# PJM Manual 12: Balancing Operations v52 Revision Summary

## **M-12 Version 52 Revisions**

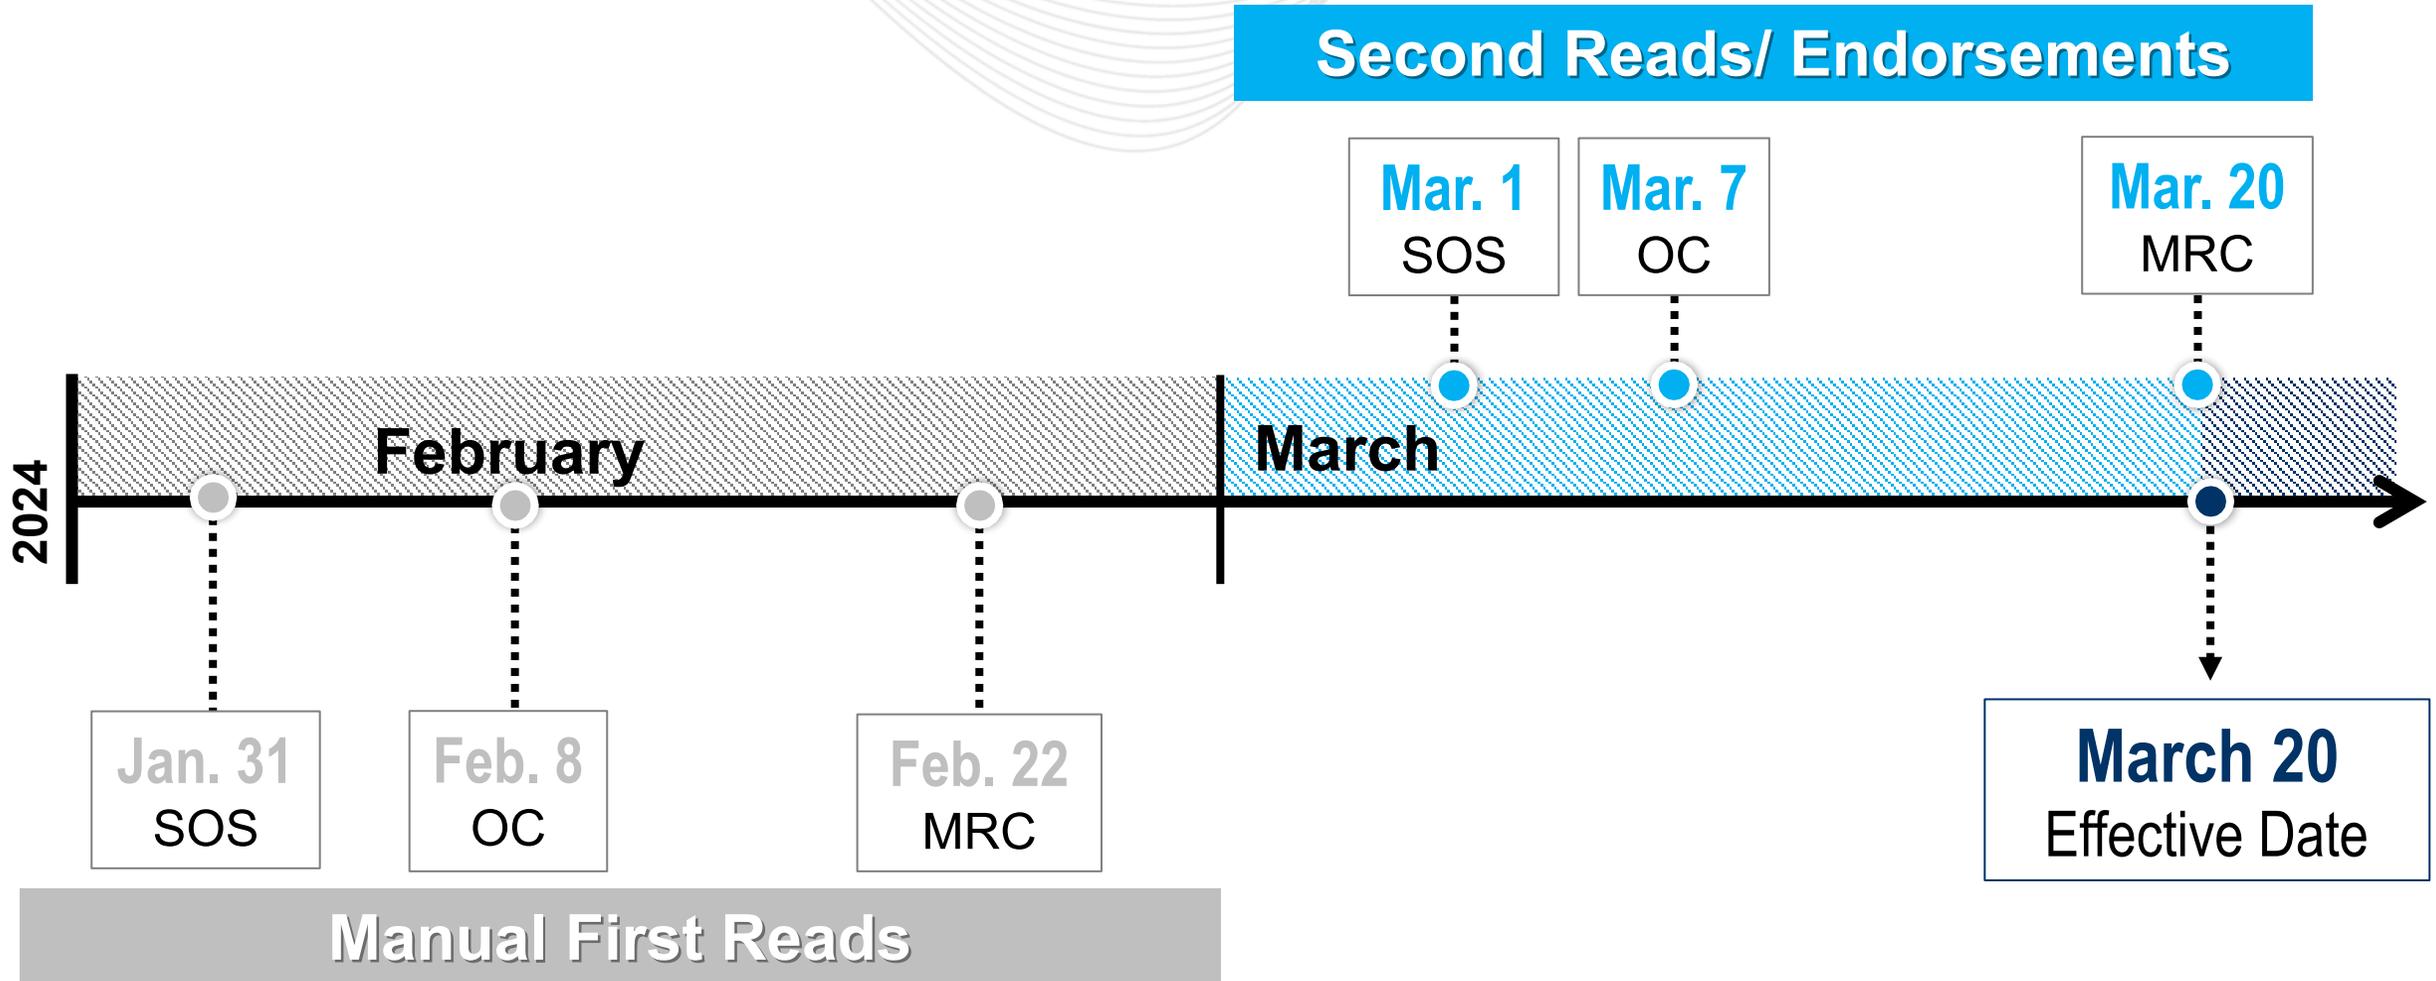
- Notes modified to include hybrid resources

3: An intermittent or hybrid resource's Economic Minimum shall represent the lowest operating MW point of the resource.

4: An intermittent or hybrid resource's Emergency Minimum should be set to 0.

- Notes added

- Note 5: The output of a hybrid resource should achieve its dispatch point within 5 minutes or consistent with the resource's ramp rate bid. PJM should be notified if the response time is expected to exceed 5 minutes
- Note 6: : The operator of a hybrid resource that is dispatchable must indicate to PJM the hours for which the plant is operating in "intermittent-only" mode, during which time the battery is not providing power for the purpose of maintaining hybrid output consistent with PJM dispatch. Dispatchable hybrids must follow dispatch in both "intermittent-only" mode and all other hybrid modes.
